**Federal Highway  
Administration**

September 27, 1994

Refer to: HNG-14

Your September 7 and September 19 letters provided crash test data on the TRITON barrier and a summary of encroachment probabilities intended to show that the TRITON could be expected to perform satisfactorily under many work zone conditions. Based on these data, you requested that the Federal Highway Administration (FHWA) accept the TRITON for use at locations where speeds would be as high as 100 km/h. Our original acceptance letter limited its use to locations where expected speeds were under 70 km/h. This acceptance was based on successful completion of the National Cooperative Highway Research Program (NCHRP) Report 350 test series for a Test Level 2 barrier.

# TRITON Installation Deflection Curves

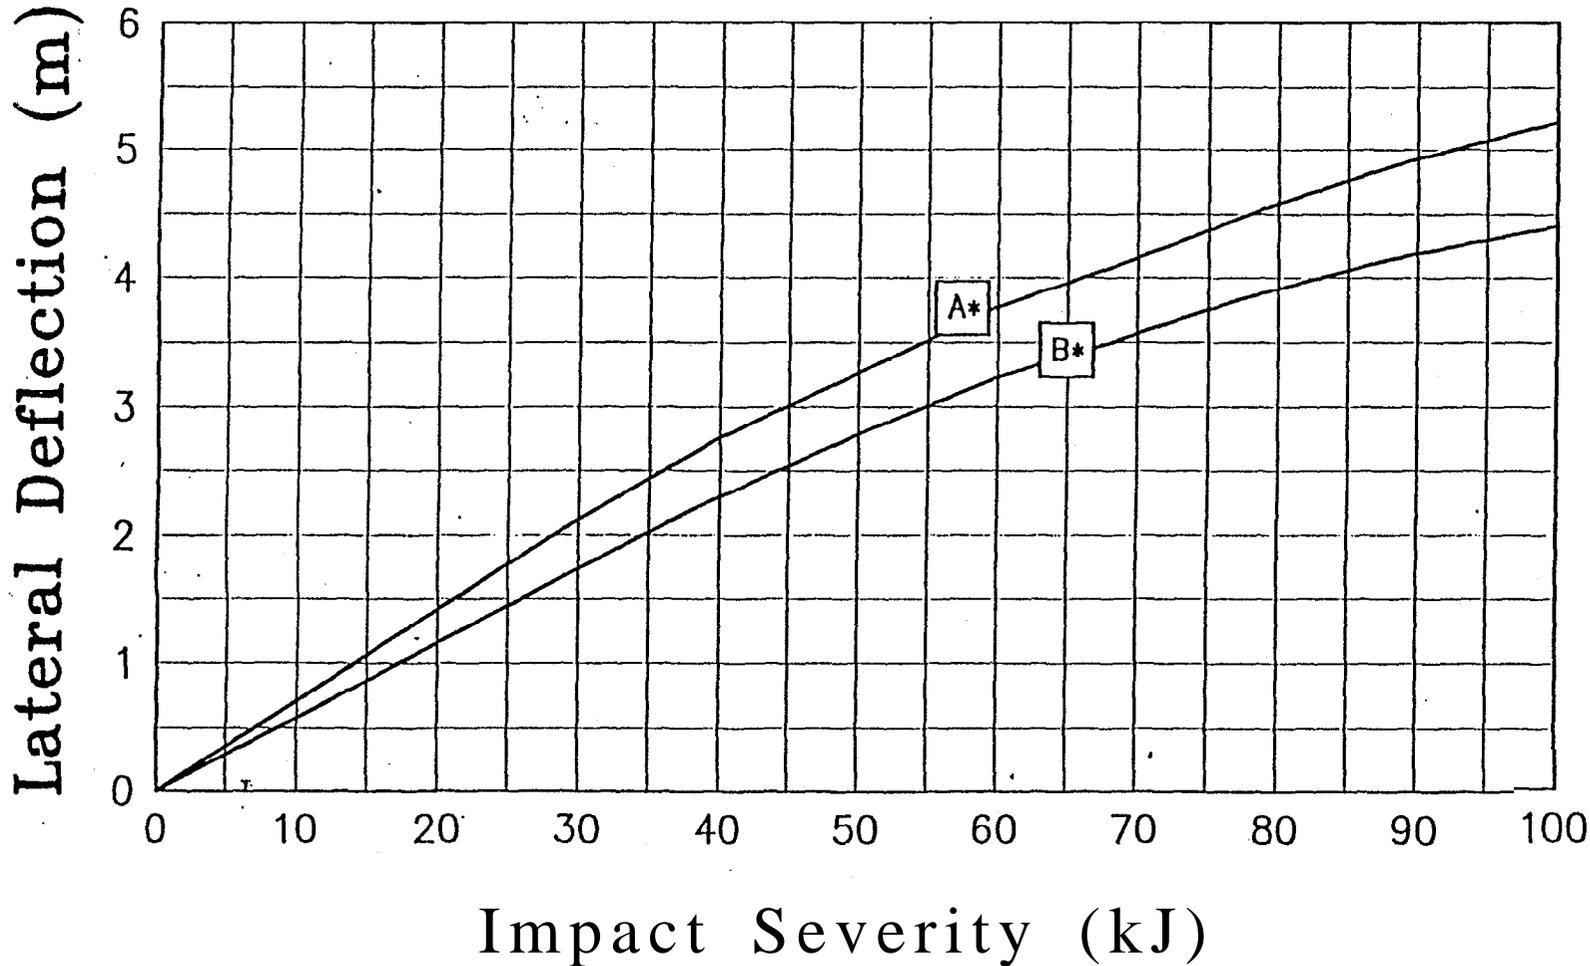
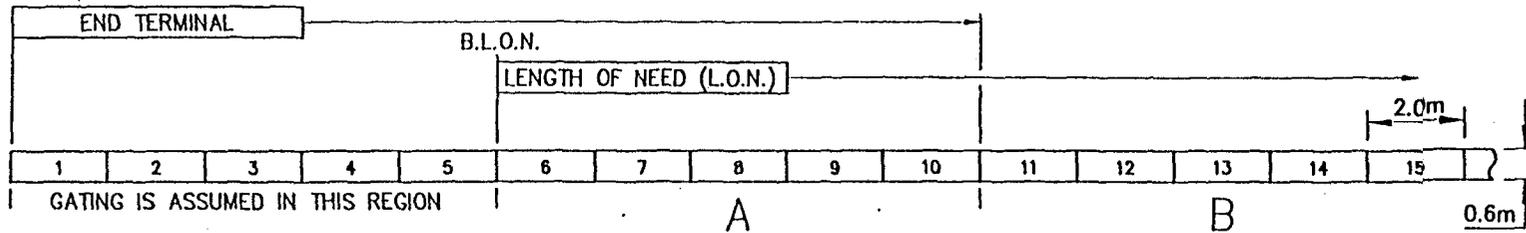
In all of the cases suggested above, the roadside surface condition and the available deflection distance from the barrier to fixed objects, edge drop-offs, and workers must be consistent with TRITON performance characteristics. This determination can be made from the deflection-impact severity curve which was submitted with your request and will be sent to FHWA field offices with a copy of this letter.
